## SERVICE BULLETIN

### No. SB-NG-1-21

| <b>Subject:</b>           | <b>Starter Solenoid Circuit</b>   |
| <b>Aircraft affected:</b> | EXTRA NG: S/N NG019, NG021 through NG025 and those retrofitted with ACS A-510-2 Ignition Switch.  |

*Figure 1: Starter Solenoid on Electrical Main Board*

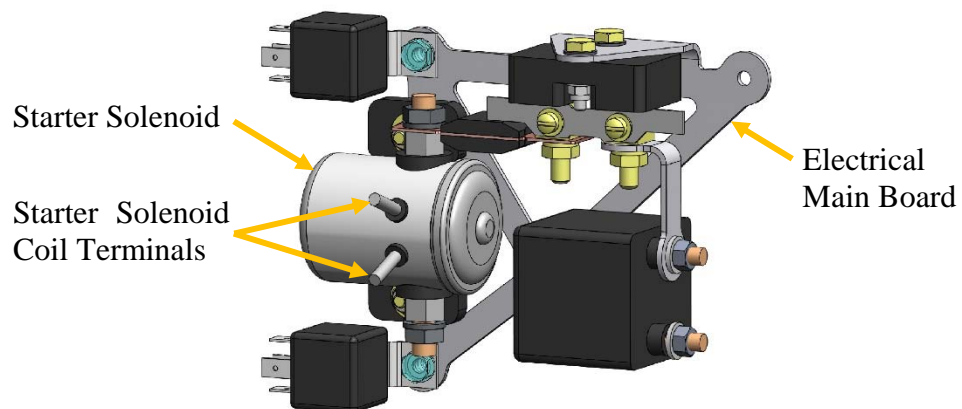
1. Make sure the aircraft is powered down.
2. Remove the bottom fuselage access panel as per Chapter 51-00-01 and 53-30 of the EXTRA NG MM and disconnect the main battery.
3. The starter solenoid is installed on the electrical main board, see Figure 1 and 2. The electrical main board is installed behind the LH landing gear cuff, see Chapter 51-00-01 of the EXTRA NG MM.

Figure 2: Electrical Main Board behind LH Landing Gear Cuff

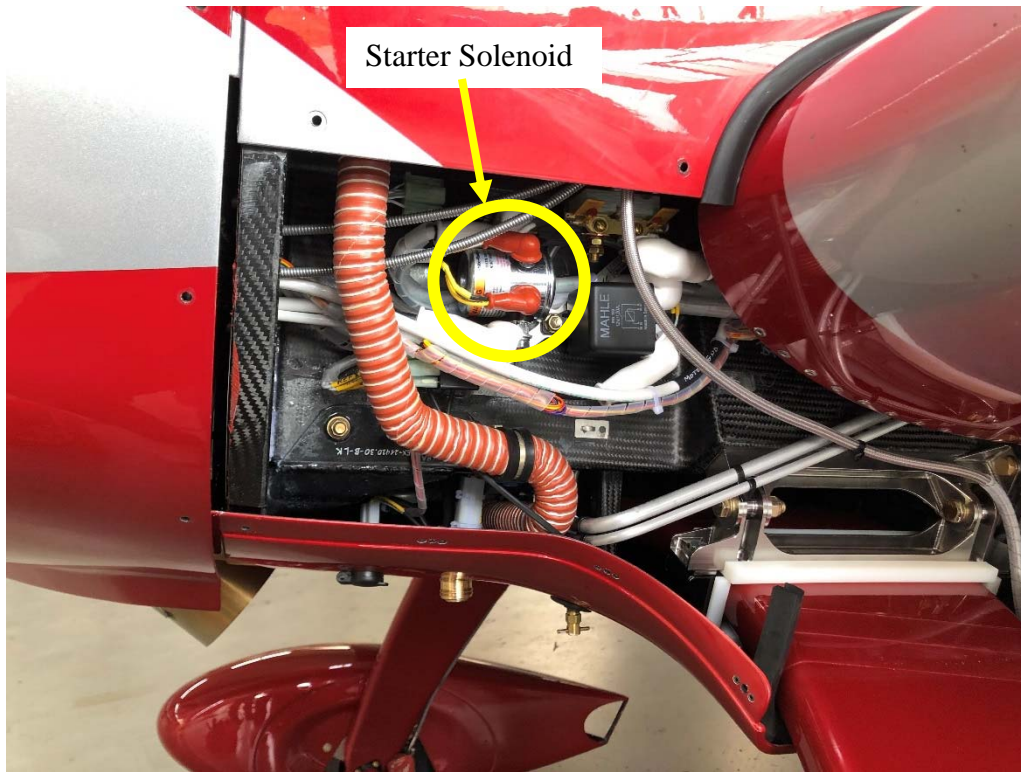
4. Remove top and bottom halves of the engine cowling as per Chapter 71-10 of the EXTRA NG MM.
5. Remove the LH landing gear cuff as per Chapter 53-30 of the EXTRA NG MM.
6. Note that the coil of the solenoid does not have a positive and a negative terminal. The coil causes a magnetic field that attracts the relay plunger regardless of the direction of the magnetic field. The positive terminal is connected to the Slickstart module and ignition switch. Both coil terminals are protected with a cover nipple.
7. Identify the starter solenoid positive coil terminal and remove the cover nipple, the nut and the washer. Use a back-up wrench to hold the bottom nut stationary when releasing the outer nuts.
8. Remove the ring terminal from the black wire with the red heat shrink tubing band (wire between coil terminals with flyback diode).

Figure 3: Starter Solenoid Wiring with opposite oriented Diodes

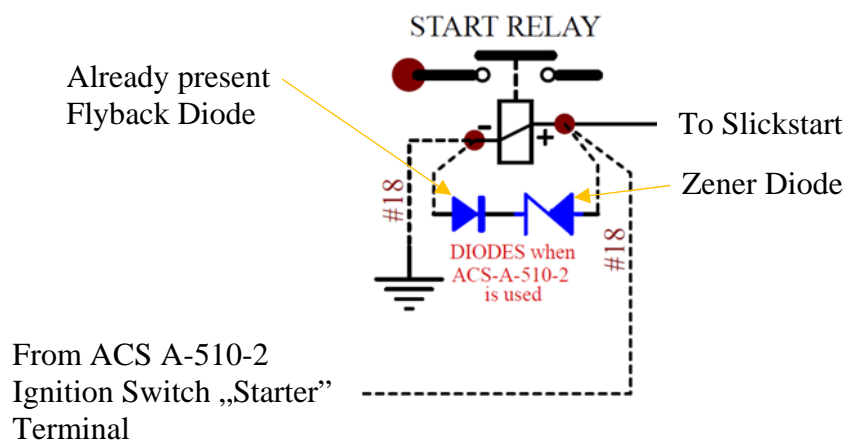
9. Cut the wire between the flyback diode and the loose ring terminal and dispose of the ring terminal.
10. Remove the insulation on the remaining wire.
11. Attach the Zener diode (EXTRA P/N 35842) in opposite direction of the present flyback diode using a crimp contact (EXTRA P/N FE4108), see Figure 3.

12. Put on heat shrink tubing long enough to cover the complete area.
13. Attach a 20 AWG aircraft wire (MIL-W-22759, EXTRA P/N 00775) with a ring terminal (EXTRA P/N 02198) to the other end of the Zener diode using a crimp contact (EXTRA P/N FE4108).
14. Pull back the heat shrink tubing to cover all parts and connections and use a heat gun to shrink it in place.
15. Install the ring terminal on the positive coil contact and attach with previously removed nut and washer (Max torque 45-55 inch-lbs / 5–6.2 Nm). Use a back-up wrench to hold the bottom nut stationary when applying the outer nuts.
16. Reinstall the cover nipple on the starter solenoid positive coil terminal.
17. Reconnect the battery.
18. Test the starter solenoid circuit for proper operation.
